Extra

May 11, 1994

SUBJECT: Revisions to Construction Standards

Several changes are being made to existing Construction Standard Drawings and the Construction Standards Index.

DESIGN APPROVED	STATE OF ARIZONA DEPARTMENT OF TRANSPORTATION DIVISION OF HIGHWAYS STANDARD DRAWINGS	3/94
APPROVED FOR DISTRIBUTION	RUB RAIL	DRAWING NO. C-10.80 Sheet 1 of 2

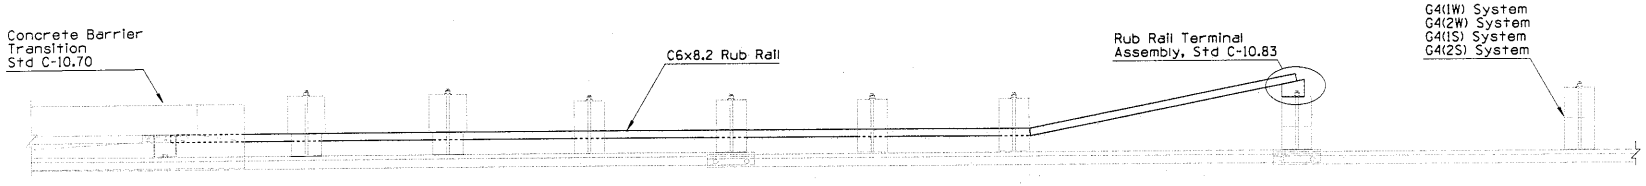
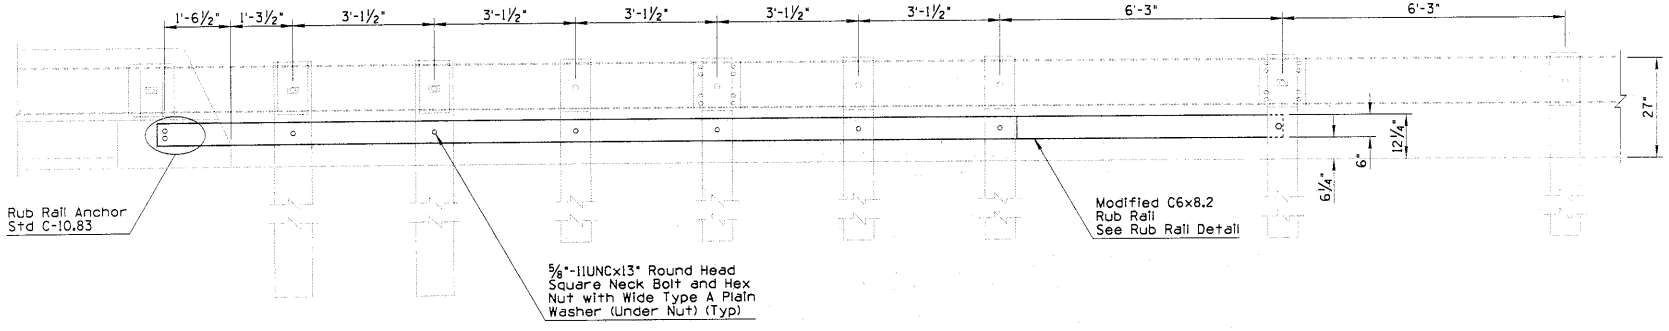
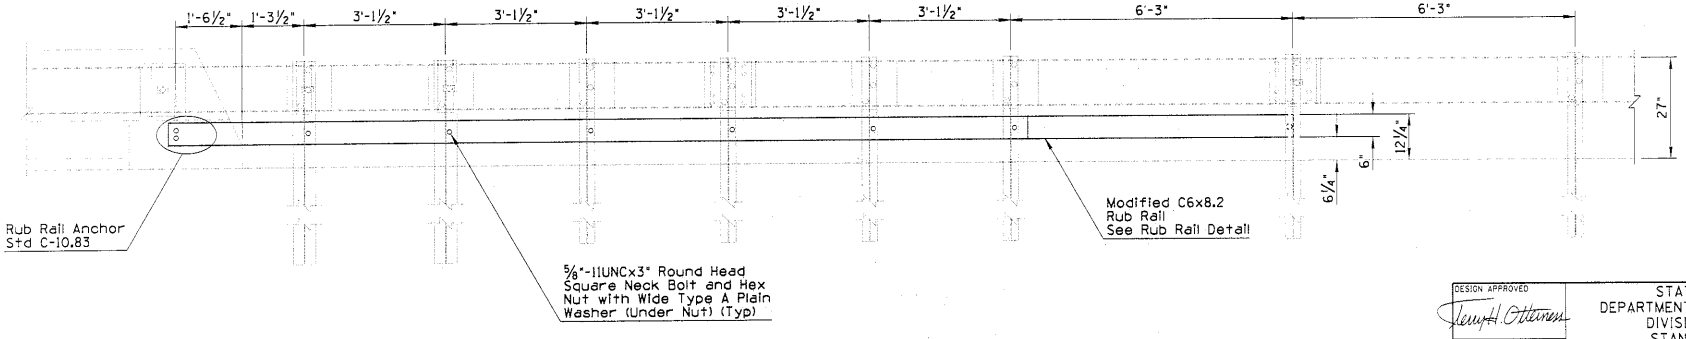
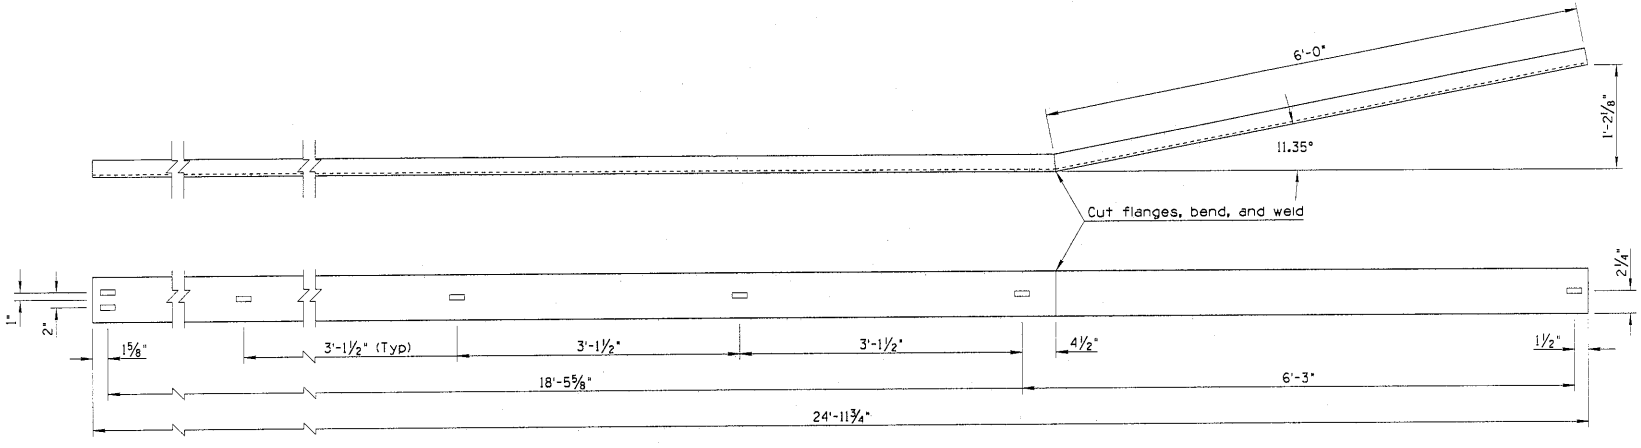
REVISED DRAWING	REVISION
C-10.74 Hardware for Concrete Barrier Transitions	New standard.
C-10.80 Rub Rail	New standard from portions of old Stds C-10.25, C-10.30, C-10.35 & C-10.40. Standard 25' length of rub rail is to be cut, bent, and welded. End of rub rail is attached to last guard rail post with an additional blockout.
C-10.83 Hardware for Rub Rail	New standard.
C-10.97 Glare Screen	Added details showing location of glare screen on median barrier. Added detail that shows the routing of the top and bottom tension wires. Deleted size of hole for expansion anchor bolts. Added three types of wire ties for fastening the tension wires to the posts. Added a note and detail indicating that the glare screen fabric shall be installed such that it blocks headlight glare. Added details clarifying assembly of the top and bottom bolts. Changed the large Type B washer. Added a detail for when the glare encounters an obstruction.

DESIGN APPROVED APPROVED FOR DISTRIBUTION	STATE OF ARIZONA DEPARTMENT OF TRANSPORTATION DIVISION OF HIGHWAYS STANDARD DRAWINGS	REV. 3/94
	GLARE SCREEN CONCRETE MEDIAN BARRIER	DRAWING NO. C-10.97 Sheet 1 of 3

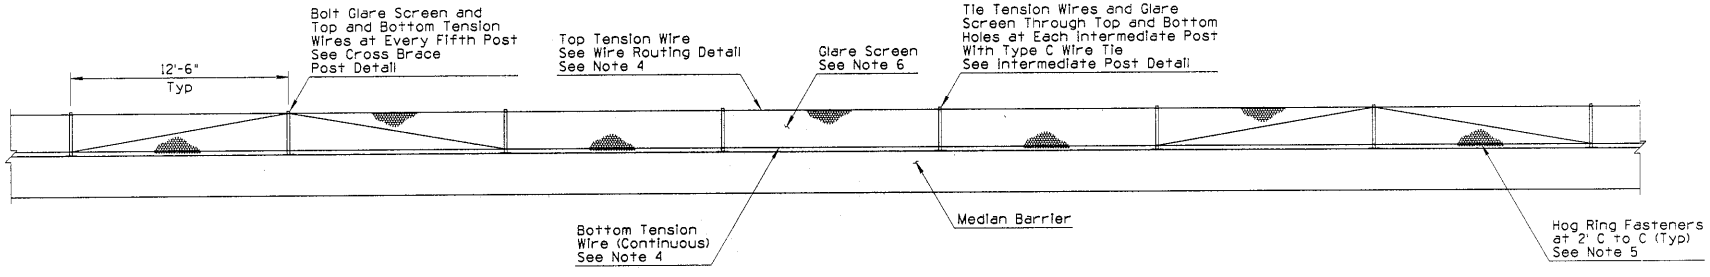
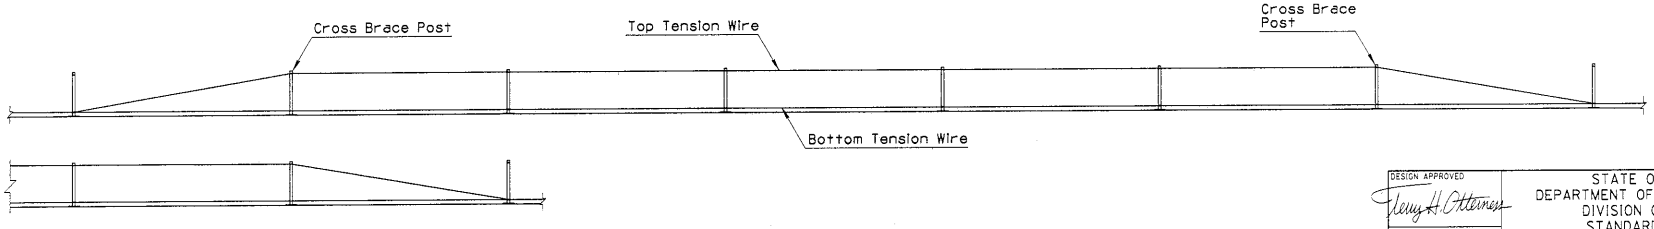
NO	DESCRIPTION OF REVISIONS	MADE BY	DATE
1	MODIFIED STANDARD	PNB	3/94
2			
3			
4

DESIGN APPROVED APPROVED FOR DISTRIBUTION	STATE OF ARIZONA DEPARTMENT OF TRANSPORTATION DIVISION OF HIGHWAYS STANDARD DRAWINGS	REV. 3/94
	GLARE SCREEN CONCRETE MEDIAN BARRIER	DRAWING NO. C-10.97 Sheet 2 of 3

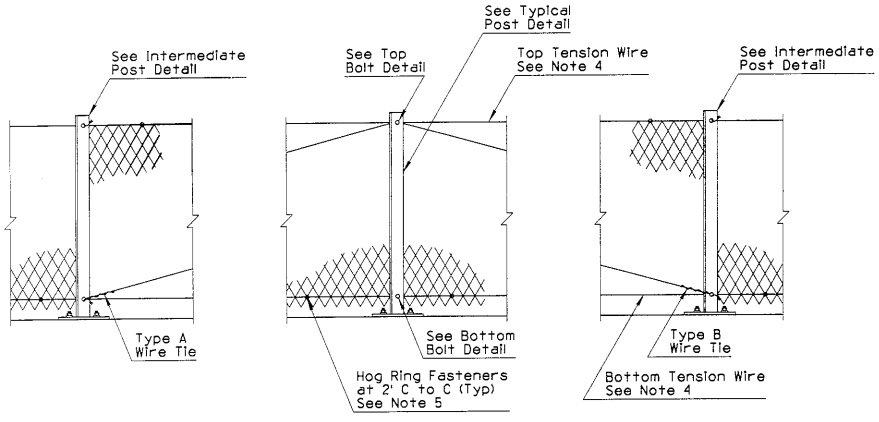
NO	DESCRIPTION OF REVISIONS	MADE BY	DATE
1	MODIFIED STANDARD & ADDED SHT 2	PNB	3/94
2			
3			
4

DRAWING NO. C-10.97
Sheet 3 of 3

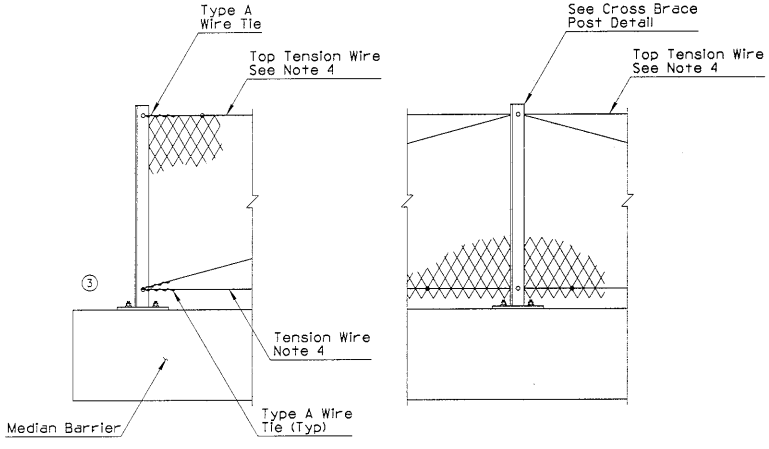
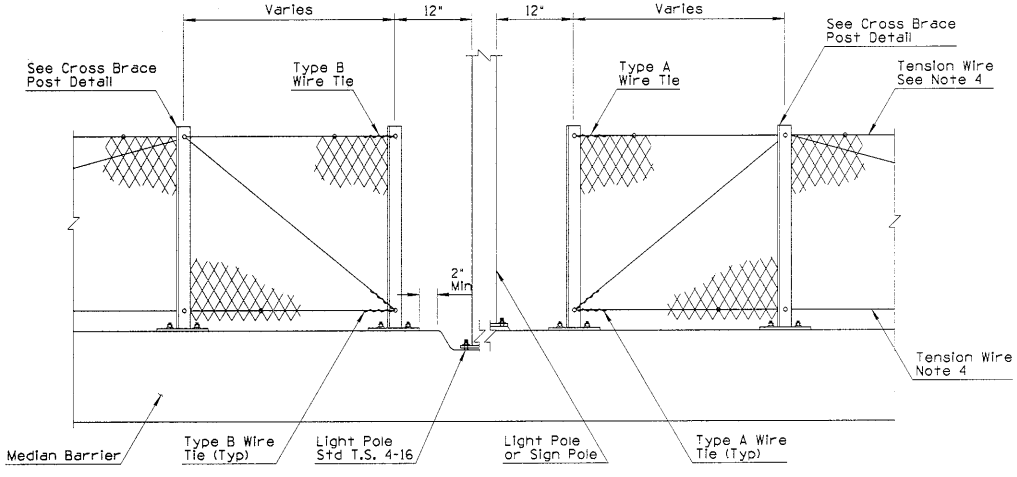
NO	DESCRIPTION OF REVISIONS	MADE BY	DATE
1	MODIFIED STANDARD & ADDED SHT 3	PNB	3/94
2	REVERSED BOLT	PNB	3/94
3	MOVED END GUY WIRE	PNB	3/94
4

DESIGN APPROVED	STATE OF ARIZONA DEPARTMENT OF TRANSPORTATION DIVISION OF HIGHWAYS STANDARD DRAWINGS	REV. 3/94
APPROVED FOR DISTRIBUTION	FENCE, CHAIN LINK TYPE 1	DRAWING NO. C-12.20 Sheet 1 of 3

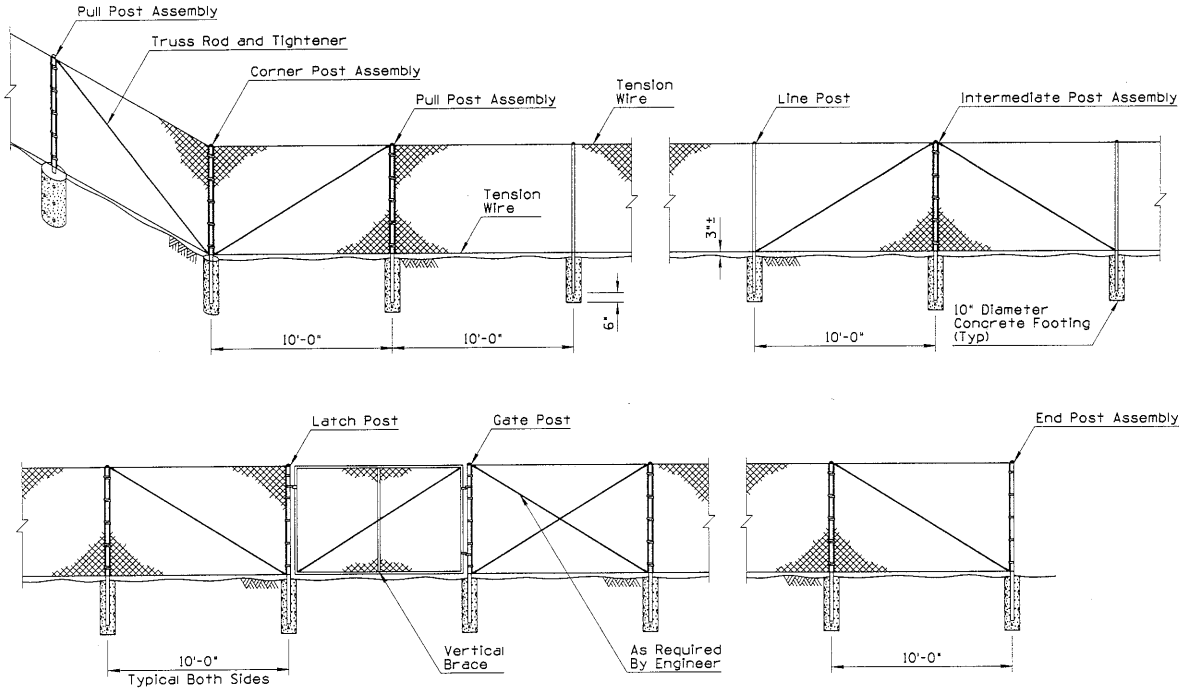
C-12.20 Fence, Chain Link	Corrected bottom clearance dimension in note six. Revised length of corner posts on Type 2 fence. Revised the typical fence location drawing.

NO	DESCRIPTION OF REVISIONS	MADE BY	DATE
1	MODIFIED DIMENSION	PNB	3/94
2			
3			
4

6. (1) Bottom tension wire shall be 3 inches from top of crown on concrete footings.
7. Intermediate post assemblies shall be spaced at 500 foot intervals or midway between pull posts when the distance between such posts is less than 1,000 feet and more than 500 feet.

DESIGN APPROVED APPROVED FOR DISTRIBUTION	STATE OF ARIZONA DEPARTMENT OF TRANSPORTATION DIVISION OF HIGHWAYS STANDARD DRAWINGS	REV. 3/94
	FENCE, CHAIN LINK TYPE 2	DRAWING NO. C-12.20 Sheet 2 of 3

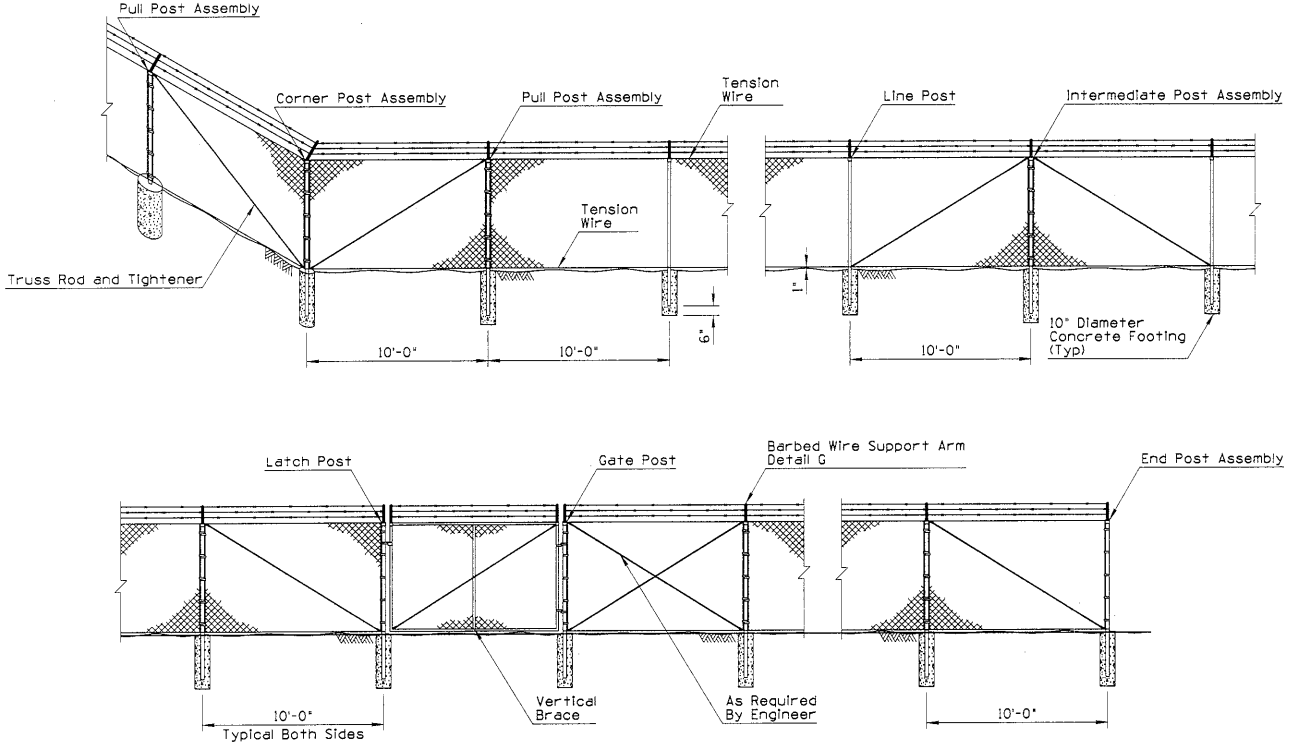
NO	DESCRIPTION OF REVISIONS	MADE BY	DATE
1	MODIFIED DIMENSION	PNB	3/94
2			
3			
4

DESIGN APPROVED APPROVED FOR DISTRIBUTION	STATE OF ARIZONA DEPARTMENT OF TRANSPORTATION DIVISION OF HIGHWAYS STANDARD DRAWINGS	REV. 3/94
	FENCE, CHAIN LINK GATES	DRAWING NO. C-12.20 Sheet 3 of 3

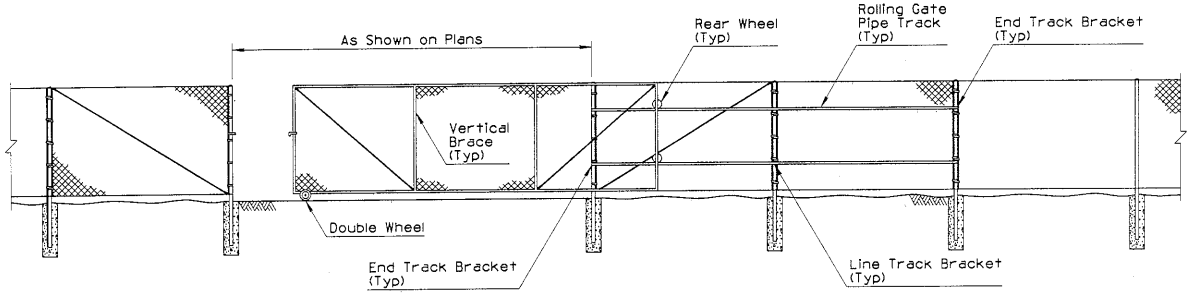
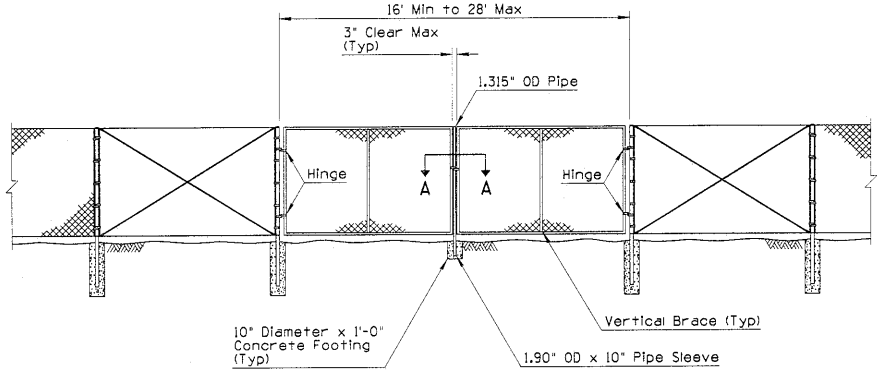
NO	DESCRIPTION OF REVISIONS	MADE BY	DATE
1	MODIFIED DRAWING	PNB	3/94
2			
3			
4
